# Murad Apparels Ltd. (9798)

ACCORD  
on Fire and Building Safety in Bangladesh

# Identified Priority 1 Concerns

## 1<sup>st</sup> Priority 3 Concern

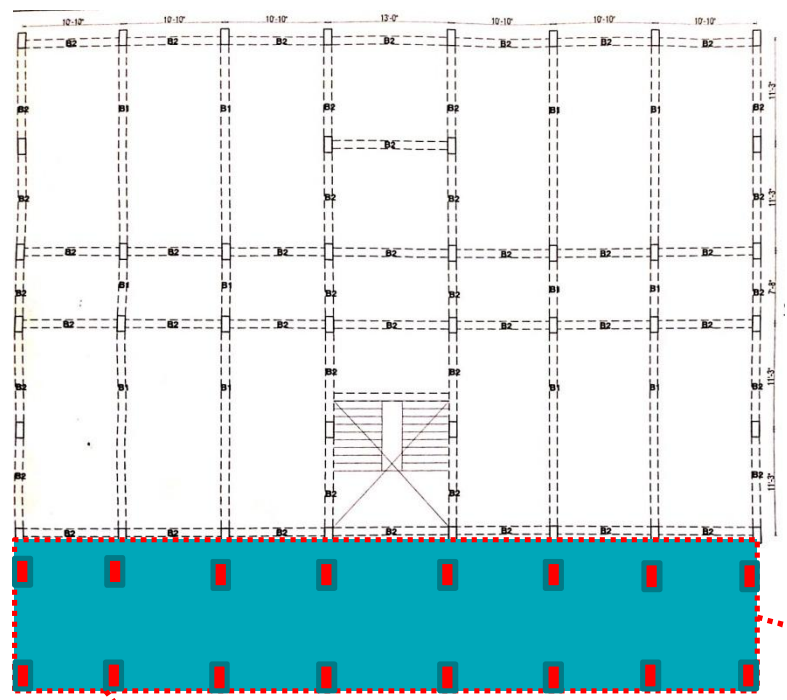
Based on the load rundown analysis of the building the column stress checking analysis gives a YELLOW status result, all floor loadings must be carefully monitored.

The construction of steel framed roof for the dining hall on the roof floor is on the permit drawings.

**The steel roof construction is not on the permit drawings**

- Carry out intrusive testing of structure to determine actual concrete and rebar strengths.
- Carry out a full survey of all structural elements and check the loading capacity of the whole structural system.
- The Factory Engineer to review design, loads and columns stresses in the entire building.

- Consider demolishing the steel framed roof extension.

## 2<sup>nd</sup> Priority 3 Concern

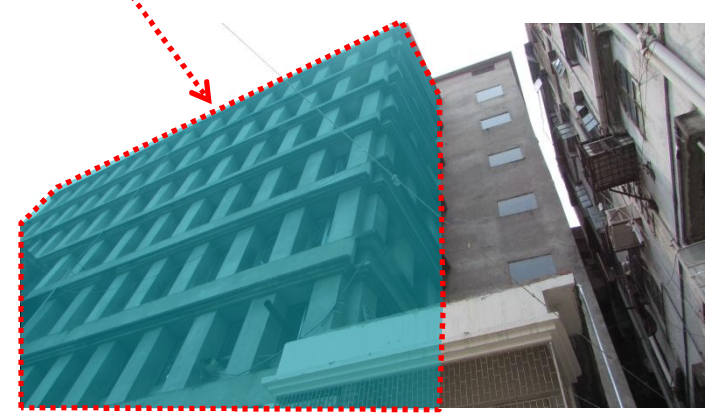
The front extension has been added to the original building. This part of the building has no structural design drawings or as-built drawings, the Factory Engineer is to review and check its structural capacity and stability.

- The Factory Engineer is to carry out thorough load checking of the entire structure, including slabs, beams and columns based on BNBC regulations and produce as-built drawings.

- In conjunction with the building survey, building engineer to produce an accurate set of as-built structural records

### 3<sup>rd</sup> Priority 3 Concern

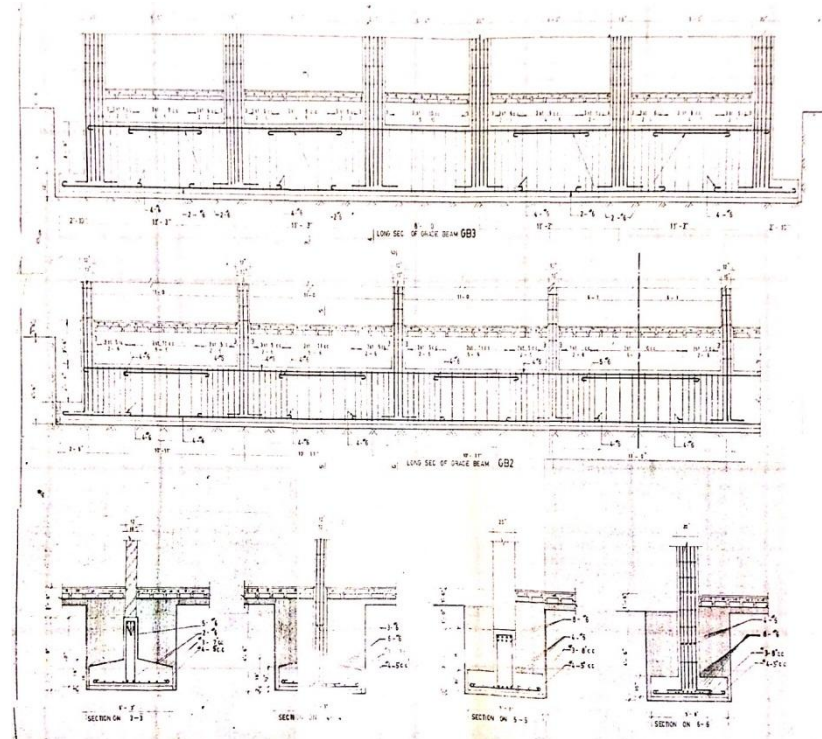
We require that these items be investigated as part of a Detailed Engineering Assessment.

The overall stability of the front extension is our main concern. There is a lack of lateral support system information. No structural drawings show any form of lateral support design.
